HP 8477A

CALIBRATOR

MANUAL CHANGES

Model Number: 8477A
 Date Printed: Apr. 77, Feb. 84
 Part Number: 08477-90003

P/O Figure 16. Power Supply Circuits (P/O Change 4)

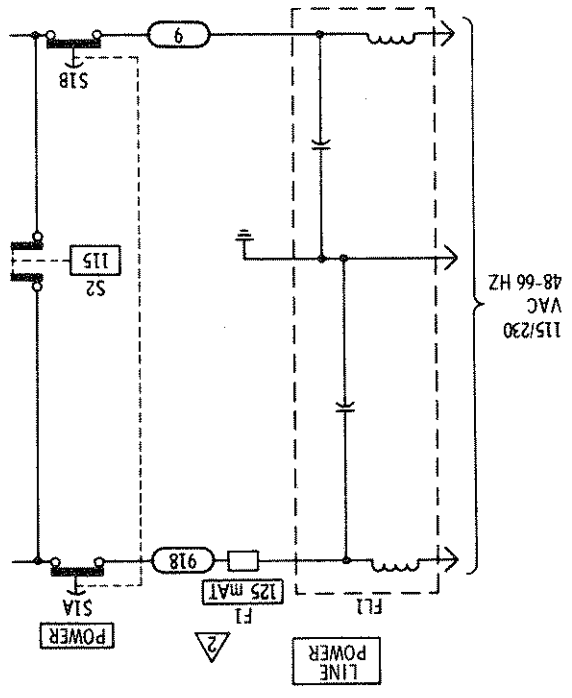
Page 27, Figure 16, Service Sheet 3:

Replace the power line portion of the schematic with the partial schematic in this supplement.

Figure 12. A1 Calibrator Circuits, Component Locations

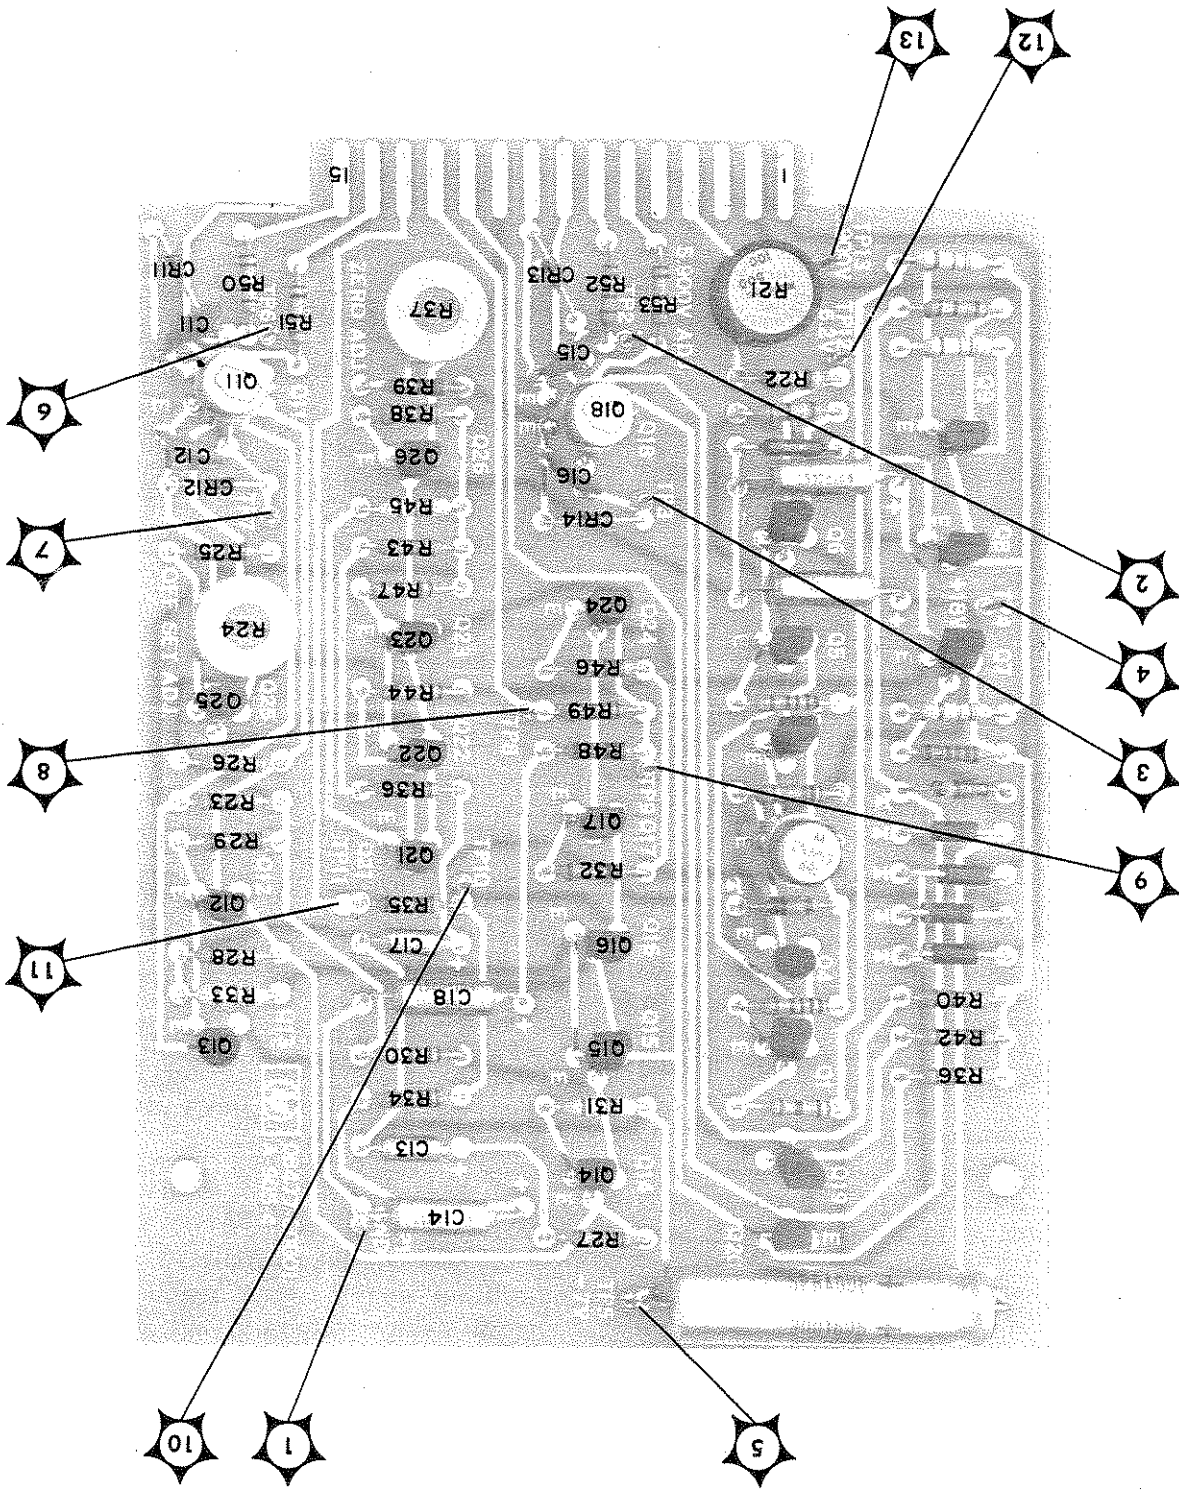
Service Sheet 2, Figure 12:

Change referenced R36, located between Q21 and Q22, to R41.

Figure 13. Calibrator Circuits

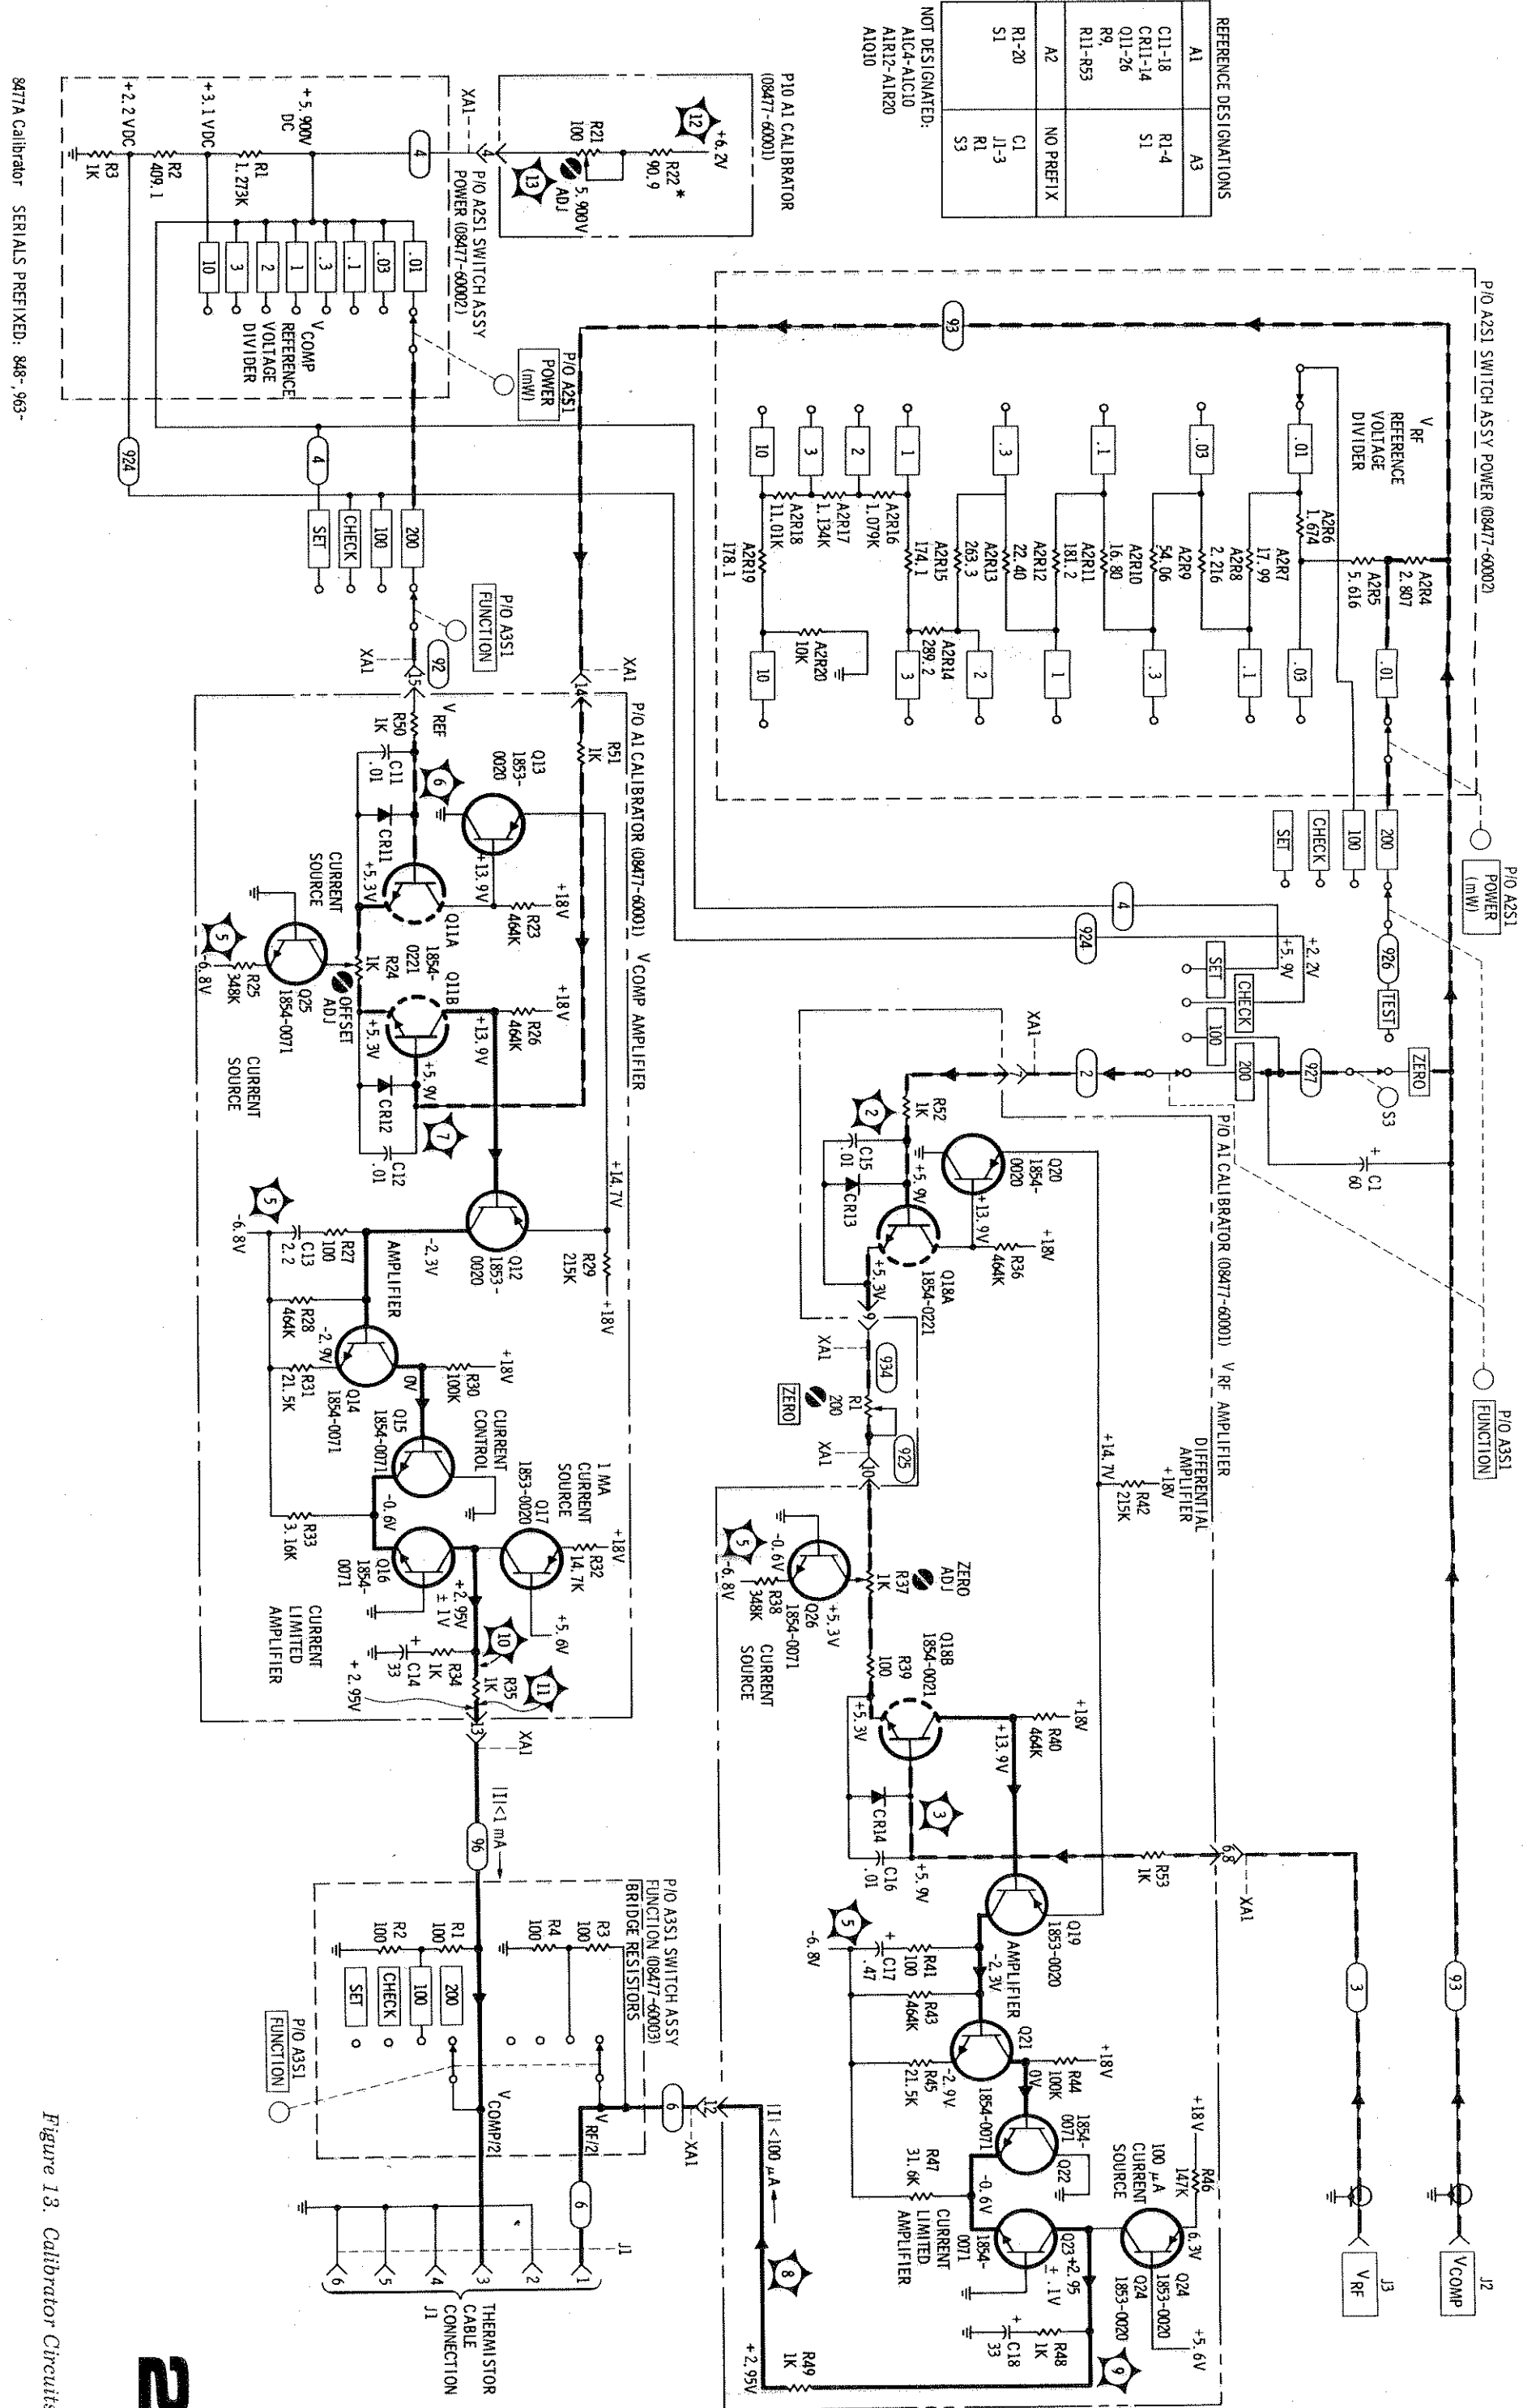
Page 25, Figure 13, Service Sheet 2:

Change the wire color connecting A3S1 to S3 from 927 to 923.

Change the following component values as indicated:

AIR27 to 21.5

AIR32 to 13.3k

AIR41 to 46.4

AIR46 to 133k.

Page 25, Figure 13, Service Sheet 2:

Change AIR21 to 200 ohms; change AIR22* to 51.1 ohms.

Figure 16. Power Supply Circuits

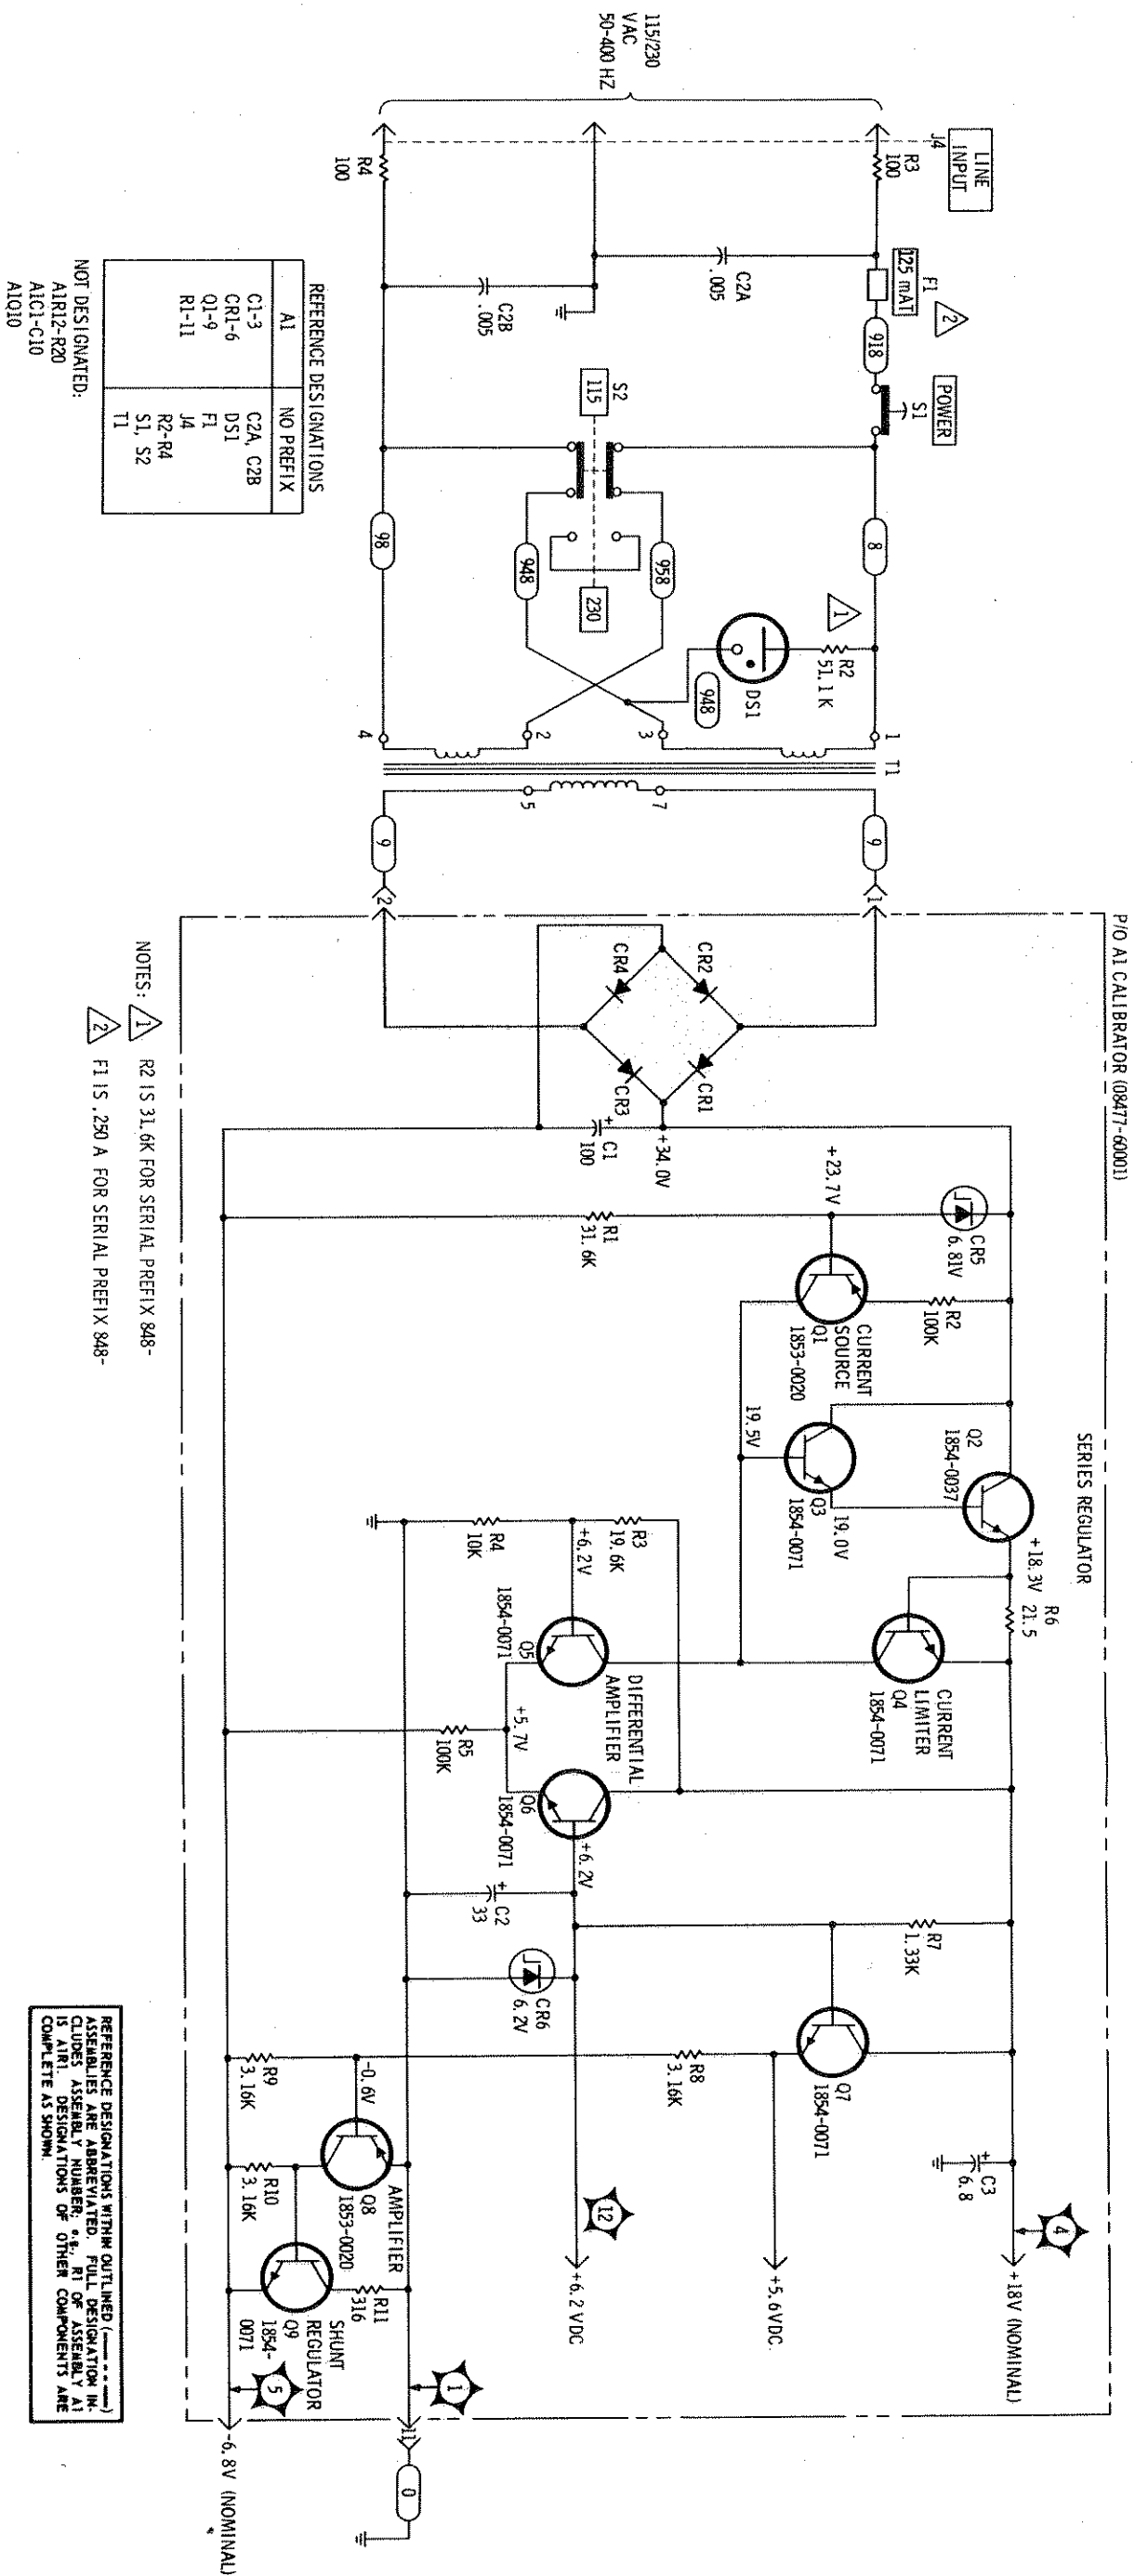
Page 27, Figure 16 (Service Sheet 3):

Change AIQ2 to 1854-0039.
